Access Compliance Report Public Rights-of-Way (Curb Ramps)

Main Street: RED_HILL_AVE Cross Street: SIERRA_ALTA_DR Location: W

ADA ID: RPRK220107121502 Ramp Type: Type 4 - Parallel Initial Pass/Fail: Pass Overall Compliance: No Severity Score: 0

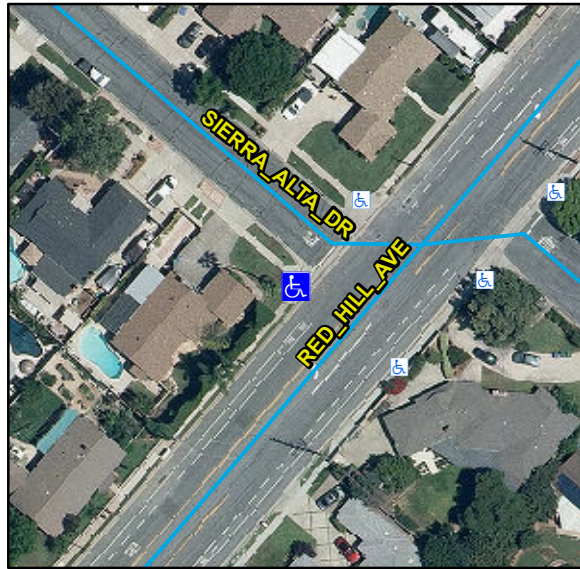
R304.5.3, STD 1115

Remove & Replace Landing.
